# MVUSD Hayfork High School
# Alterations to Classroom Bldg (Inc 1)
# BID PACKAGE MV2019.1.8 Casework

## Scope Clarification

**HAYFORK HIGH SCHOOL**
ALTERATIONS TO CLASSROOM, MULTI-PURPOSE AND ADMINISTRATION - BUILDING A INCREMENT #1

# A6.20-I1

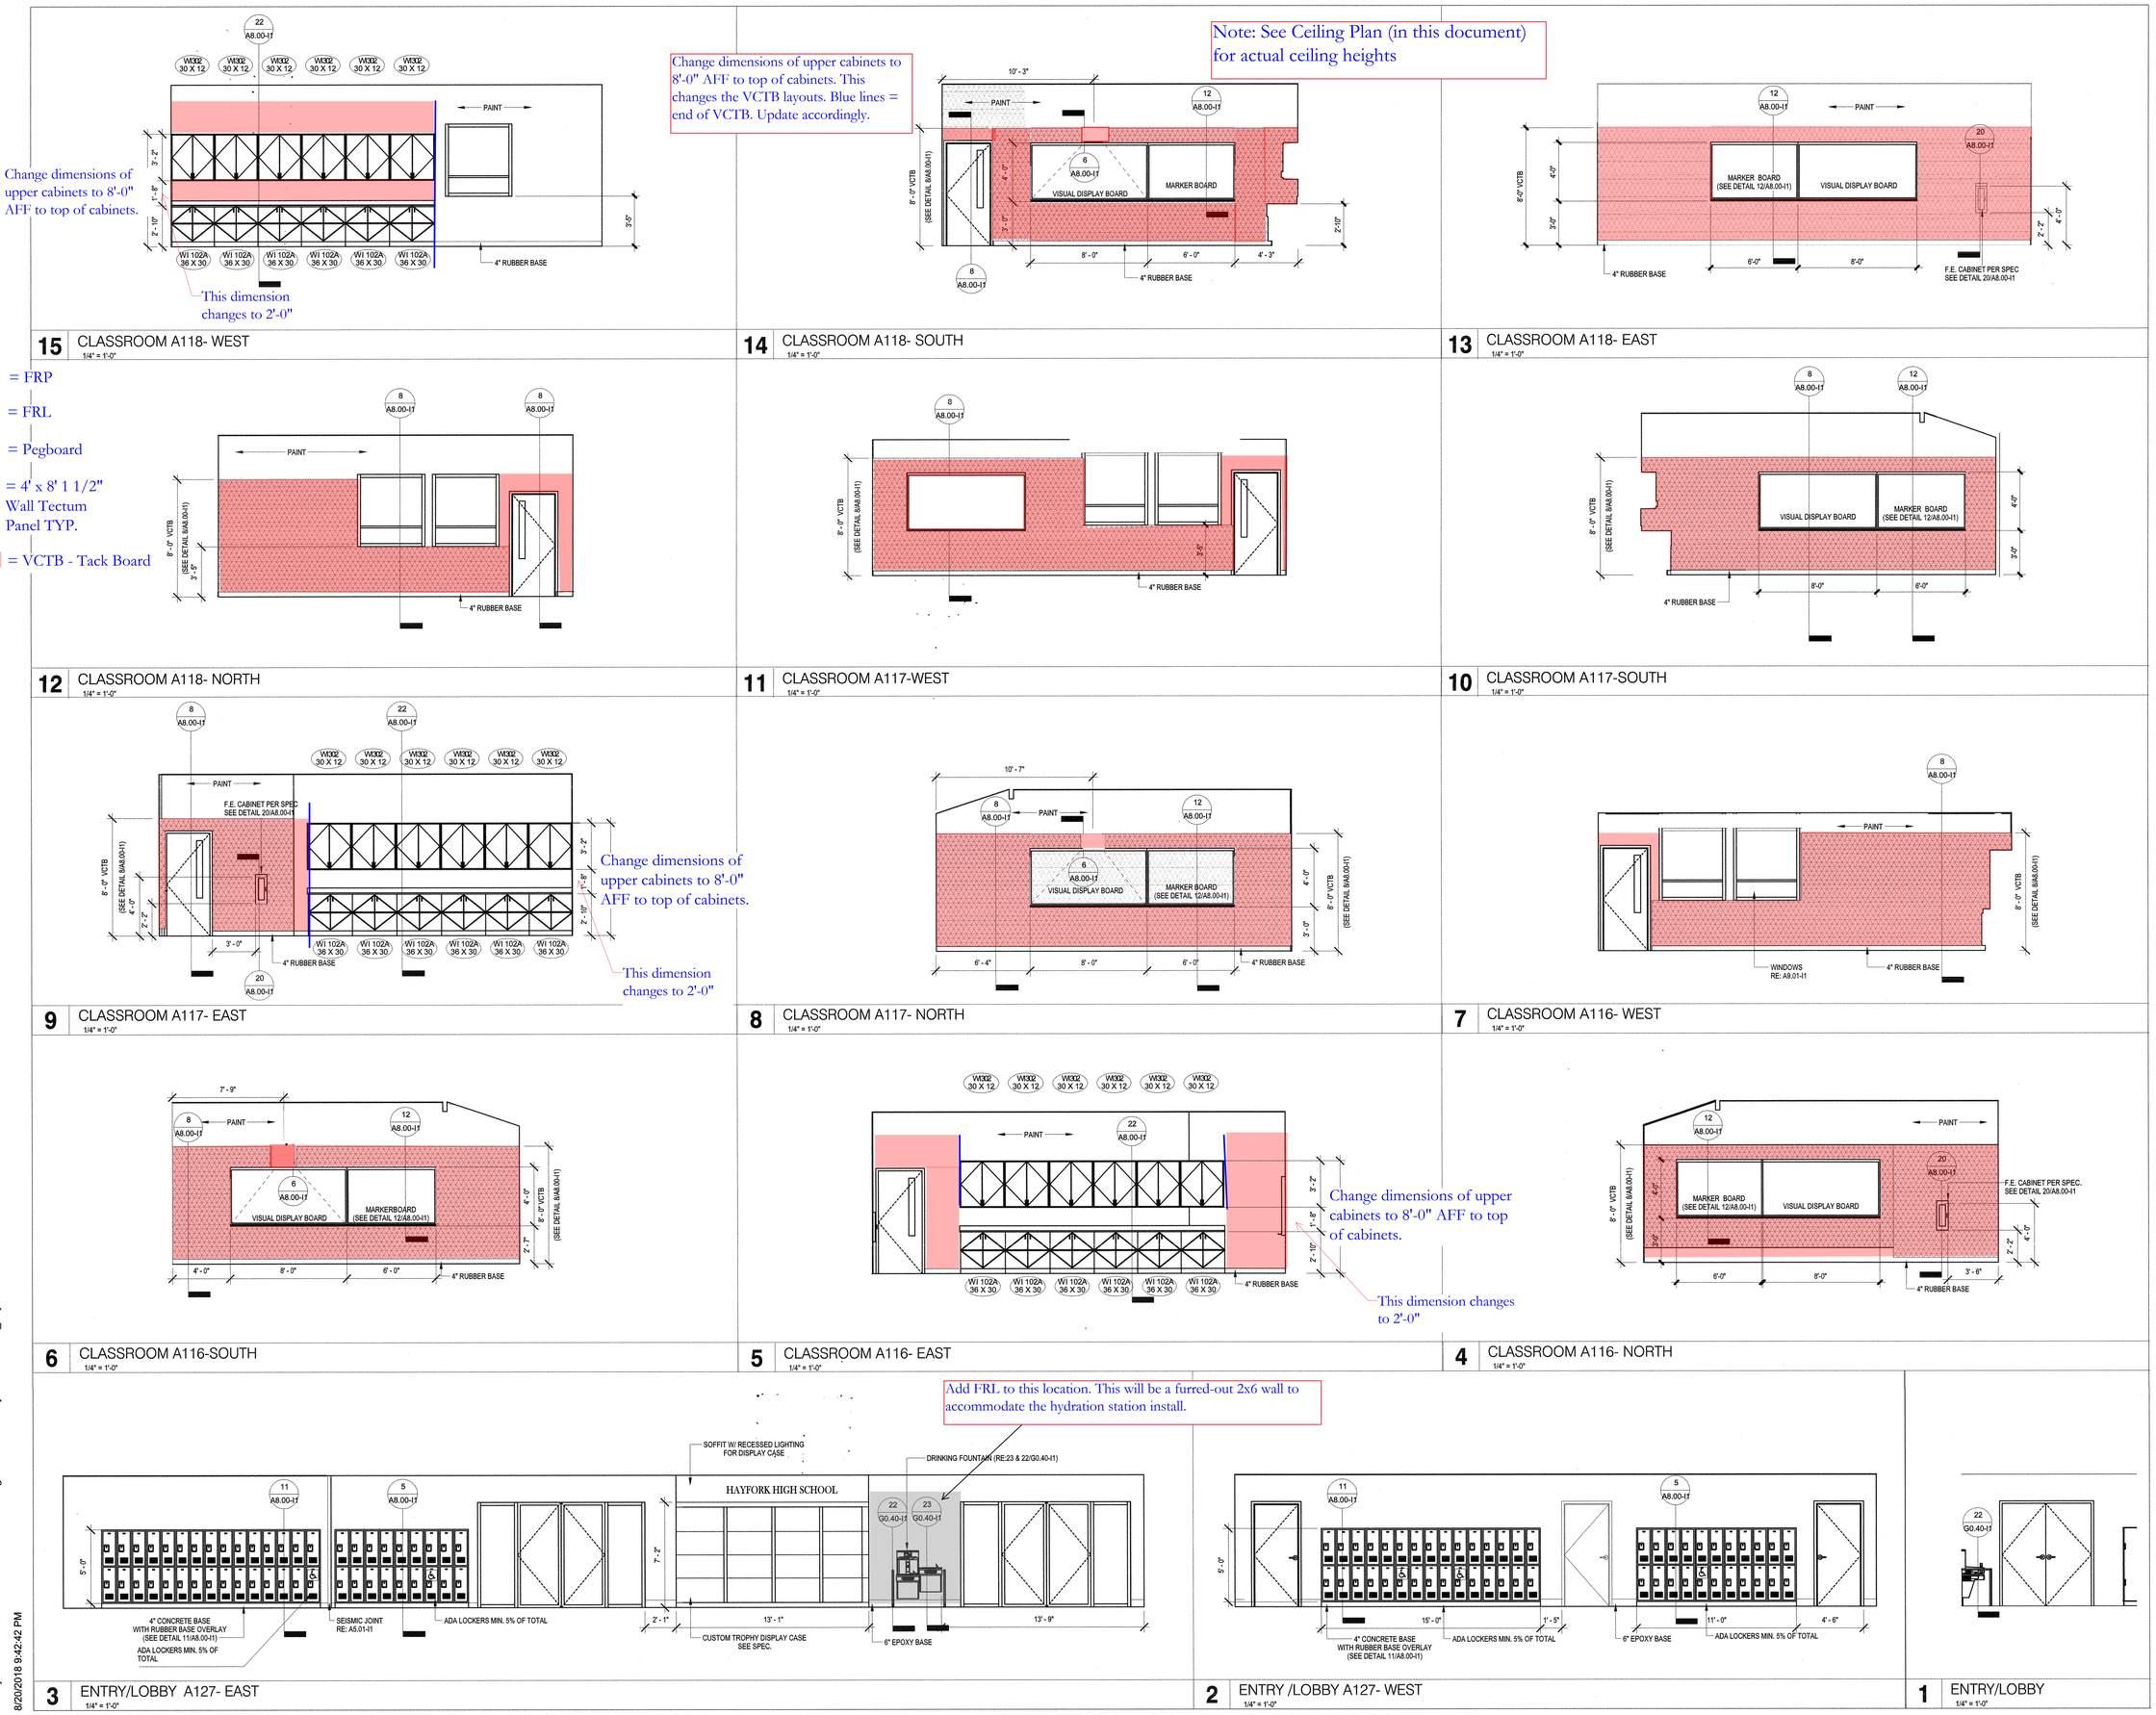
Change dimensions of upper cabinets to 8'-0" AFF to top of cabinets.
This dimension changes to 2'-0"
Change dimensions of upper cabinets to 8'-0" AFF to top of cabinets. This changes the VCTB layouts. Blue lines = end of VCTB. Update accordingly.
Note: See Ceiling Plan (in this document) for actual ceiling heights
Change dimensions of upper cabinets to 8'-0" AFF to top of cabinets.
This dimension changes to 2'-0"
Change dimensions of upper cabinets to 8'-0" AFF to top of cabinets.
This dimension changes to 2'-0"
Add FRL to this location. This will be a furred-out 2x6 wall to accommodate the hydration station install.

**28** INFO COMMONS A115- EAST
1/4" = 1'-0"

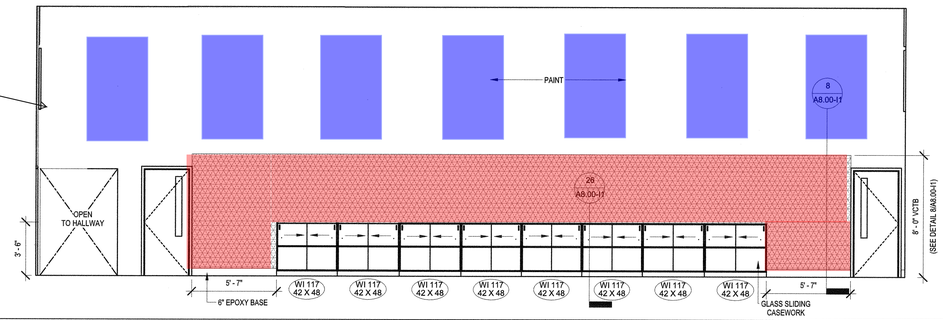
Add: 7 - 4' x 8' Tectum Panels equally spaced

**24** CLASSROOM A125- WEST
1/4" = 1'-0"

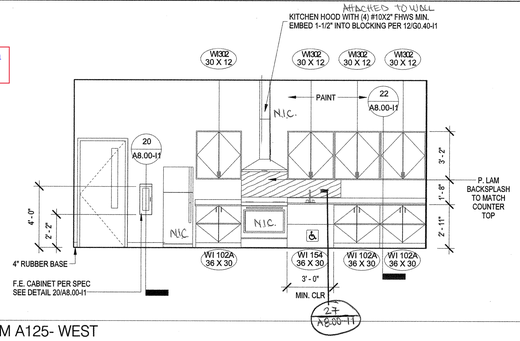
No VCTB on this wall

**16** CLASSROOM A124- WEST
1/4" = 1'-0"

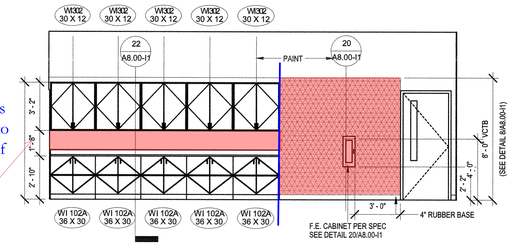
Change dimensions of upper cabinets to 8'-0" AFF to top of cabinets.

This dimension changes to 2'-0"

**8** CLASSROOM A120- WEST
1/4" = 1'-0"

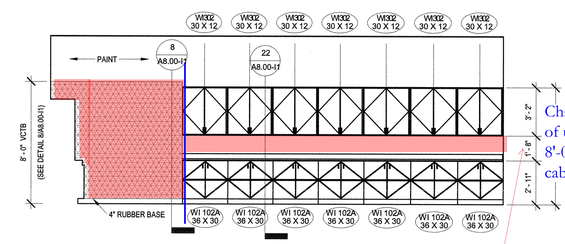
Change dimensions of upper cabinets to 8'-0" AFF to top of cabinets.

This dimension changes to 2'-0"
